**COUNTY OF ALBEMARLE
STAFF REPORT SUMMARY**

Project Name: ZMA201200007 5 th Street Commercial	Staff: Elaine Echols
Planning Commission Public Hearing: March 15, 2016	Board of Supervisors Public Hearing: TBD
Owner: FTV Investments	Applicant: Katurah Roell
Acreage: 4.35 acres	Rezoning: Modify plan and proffers for property zoned HC Highway Commercial and LI Light Industrial
TMPS: 0.875 acre portion of 07600-00-00-055A0, 3.041 acre portion of 076M1-00-00-00100, and all of 07600-00-00-055C0	By-right use: Proffers restrict the use to hotels, motels, restaurants, service stations, convenience stores, and gift, craft, or antique shops according to the proffered plan; a proffered plan shows the limits of development, reflecting a special use permit for fill in the floodplain
Magisterial District: Scottsville	Proffers: Yes
Proposal: Request to amend proffers and application plan of ZMA199900013 for 4.35 acres on property zoned HC – Highway Commercial, which allows commercial and service; residential by special use permit (15 units/ acre) and property zoned LI Light Industrial, which allows – industrial, office, and limited commercial uses (no residential use). No zoning district change an

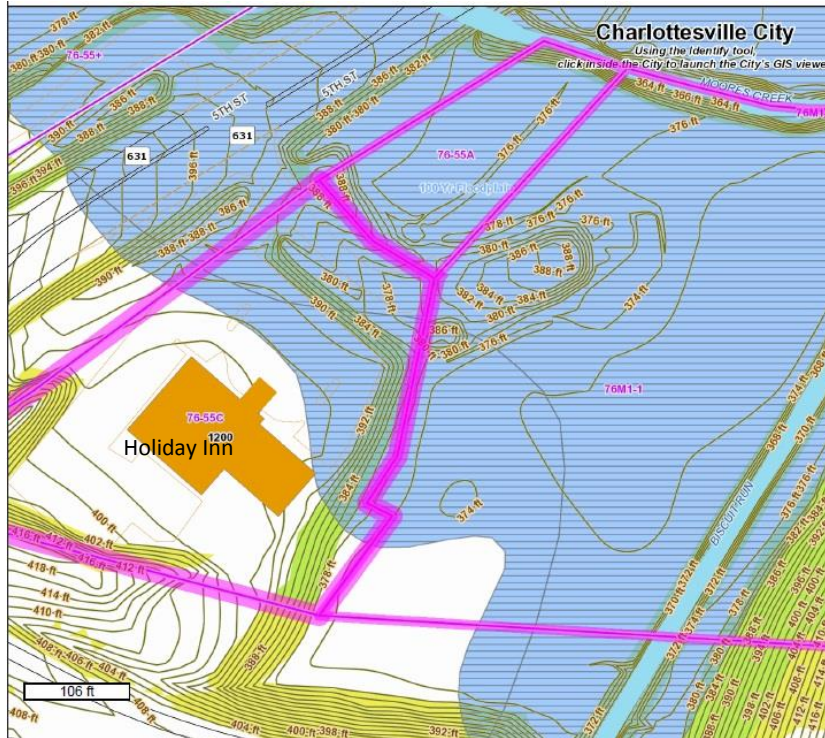
1. *Please have the application show the current floodplain limits according to FEMA mapping. The proposed line or Conditional letter of Map Revision (CLOMR) lines do not appear to be the current regulatory limits.*

2. Please have the applicant clarify the limits of floodplain fill in the context of the previous approval. It appears that the proposed retaining wall may encroach further than the slope shown on previous concept plans. This would increase the proposed fill.
3. Please correct the buffer designation on the plan, and clarify the encroachment into the stream buffers. There is no 50' buffer in the WPO. There is only a 100' buffer. Up to 50' of encroachment and disturbance is permitted with mitigation. This should be compared to what was previously approved.

The image on the left shows both the floodplain and preserved slopes. Preserved slopes have been proposed for disturbance at the entrance and behind the Holiday Inn. Disturbances in both of these areas were approved in prior ZMA and SP approvals according to the plans.
